Memo to the Programs, Projects and Operations Subcommittee

Subject: Elkhorn River IPA – Bank Stabilization Construction Project Change Orders

Date:	27 June 2012
Project:	P-MRNRD Elkhorn River IPA Bank Stabilization
Tt Project Number:	100-SWW-T27355
Change Order Number:	3

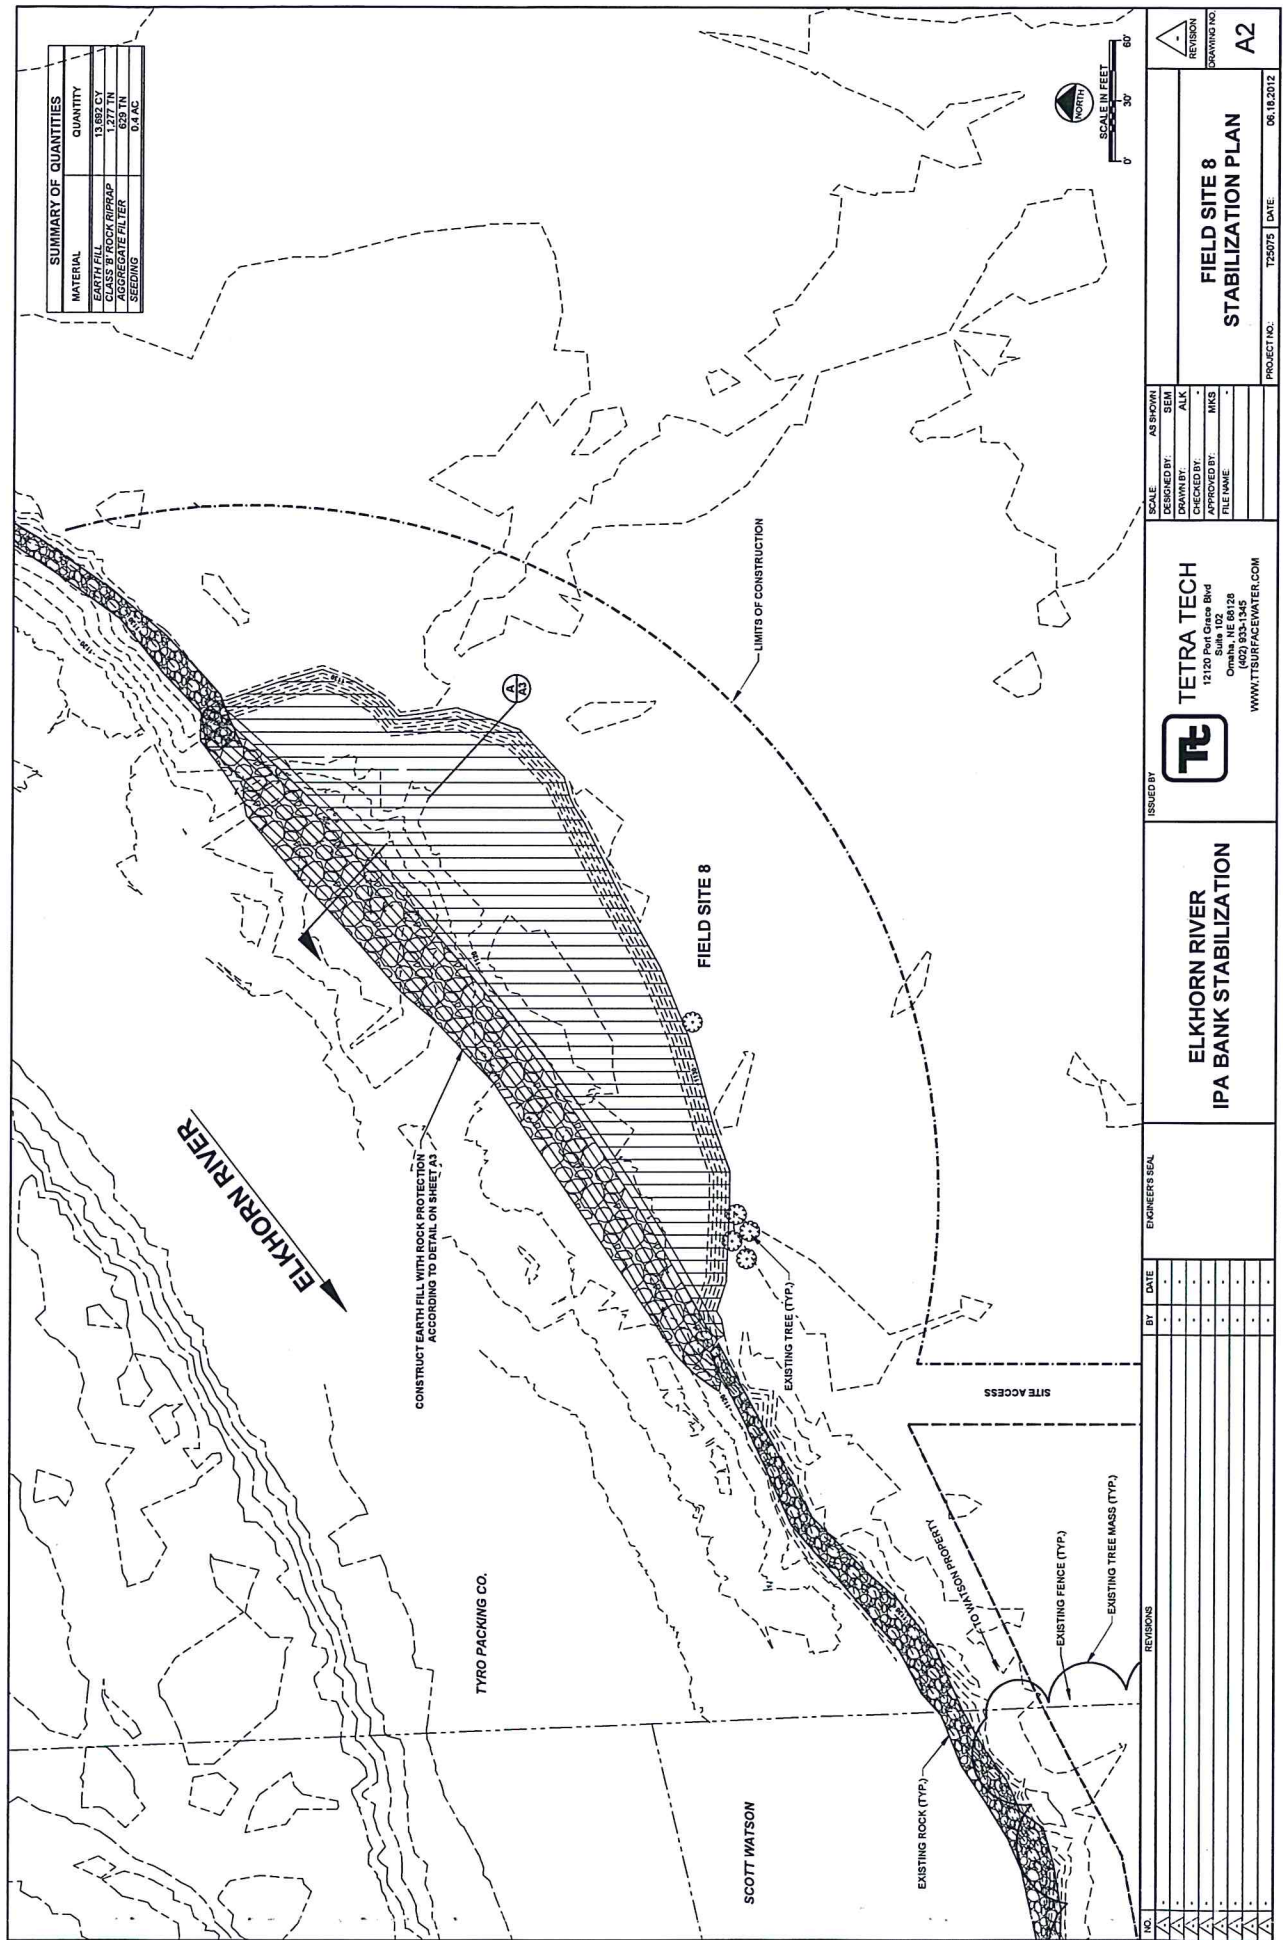
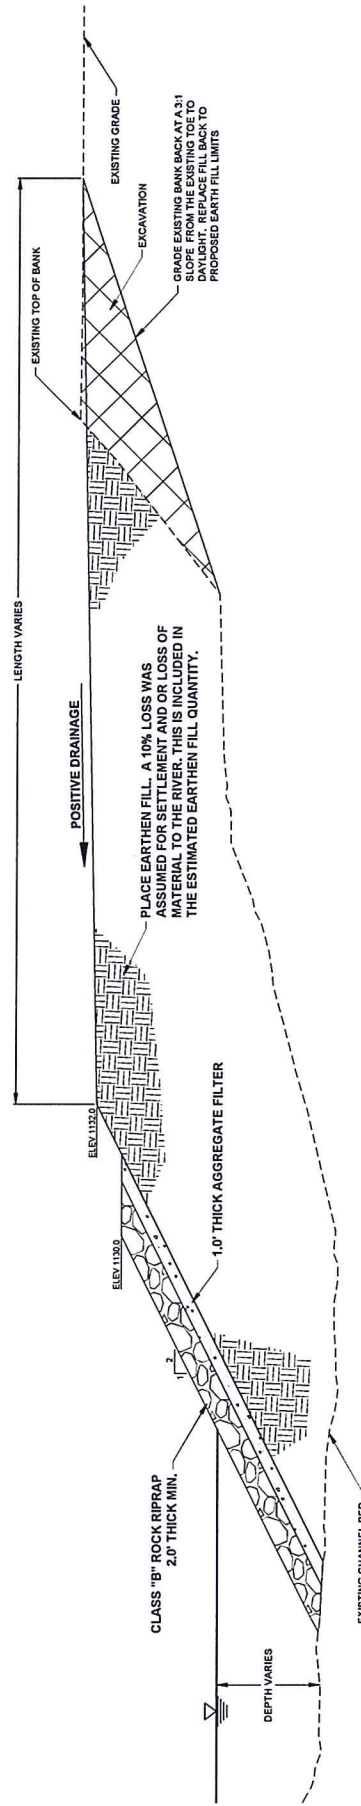
ADD 13,692 CY of earth fill (includes haul, place and compaction testing) at \$10.30/CY	\$141,027.60
ADD 1,277 tons of rock riprap at \$36.75/ton	\$46,929.75
ADD 629 tons of aggregate filter at \$26.00/ton	\$16,354.00
ADD 0.4 acres of pasture seed mix at \$1,700.00/acres	<u>\$680.00</u>

<u>DESCRIPTION</u>	<u>UNITS</u>	<u>COST/UNIT</u>	<u>TOTAL</u>
1. Acquire, haul, and place earthfill as per specifications listed	13692	\$10.30	\$ 141,027.60
2. Acquire, haul, and place type B rock rip rap on bank	1277	\$36.75	\$ 46,929.75
3. Acquire, haul, and place aggregate filter as/plan detail	629	\$26.00	\$ 16,354.00
4. Pasture seed mix as per specifications	0.4	\$1,700.00	\$ 680.00

Figure 34. Aerial photograph taken on June 16, 2010 (discharge ~37,250 cfs) of Field Site 8. Also shown are the banklines from the October 2000, October 2004 and September 2009 aerial photographs.

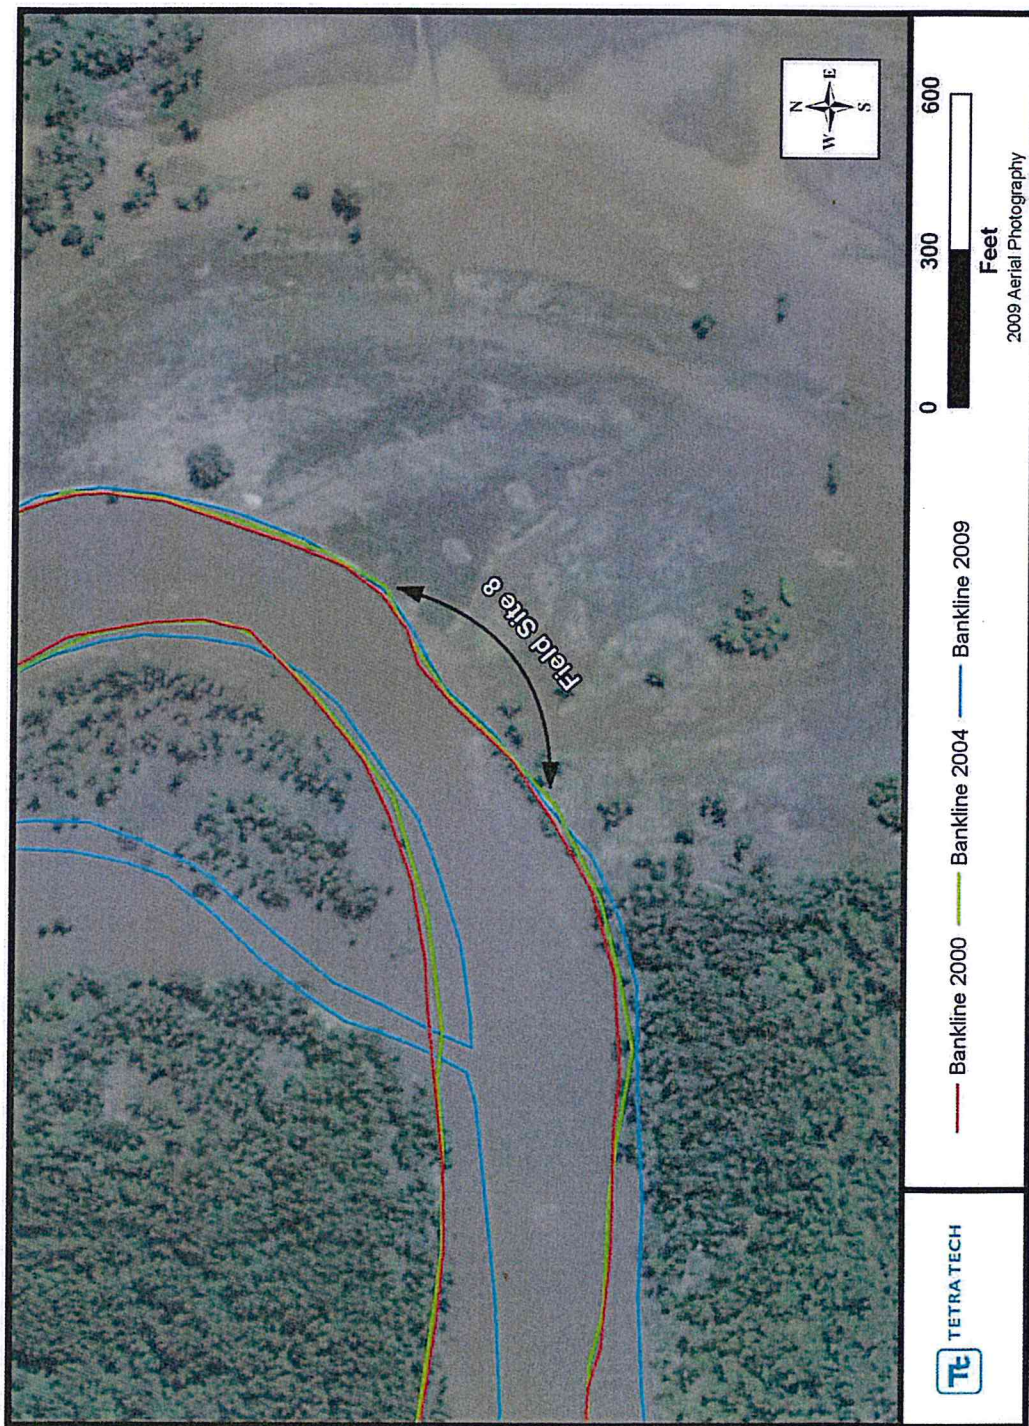
Field Site 8 is an approximately 300-foot long scallop that has developed in the left bank just downstream from a pre-existing rock spur located at the downstream end of the windrow revetment for Site 13B (**Figures 34 and 35**). The bankline at this location retreated into the overbank by nearly 80 feet downstream from the rock spur. The IPA construction plans called for cabled-tree revetment for approximately 1,000 feet downstream from the rock spur. The cabled-trees were not installed during the original construction, but windrow revetment was placed in this area in the late 1990s (**Figure 36**; Table 1, Note 16). With the exception of the scalloped area, the remainder of the bankline appears to be relatively stable at the present time.

Figure 37. Recommended re-alignment of bankline at Field Site 8 and typical cross section of the rock riprap that should be placed along the realigned bank.

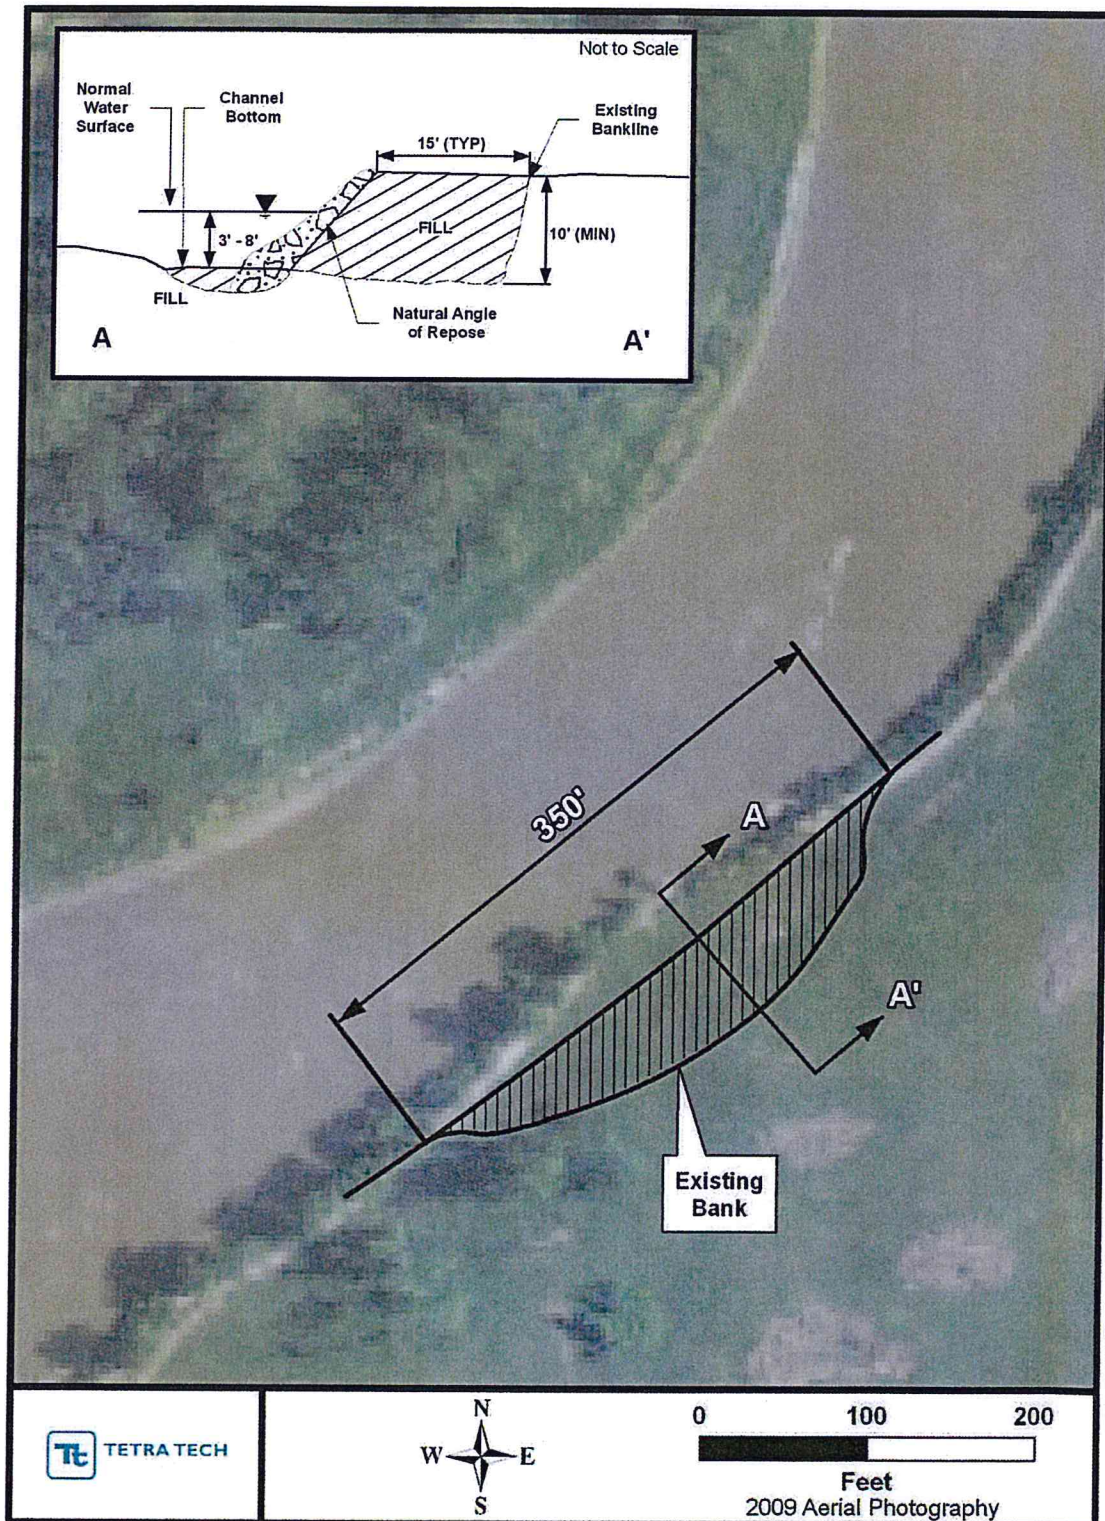
Recommended repairs at Field Site 8 include realigning the bankline to eliminate the scallop, and placement of appropriately sized rock riprap on the realigned bankline (**Figure 37**). The length of the realigned bankline would be about 350 feet, and the area that would need to be filled between the existing and new bankline is about 17,000 ft². Assuming a bank height of 12

feet, based on the topography in the IPA plans, plus approximately 5 feet of local scour on the outside of the bend, a total fill volume of about 7,600 yd³ would be required.
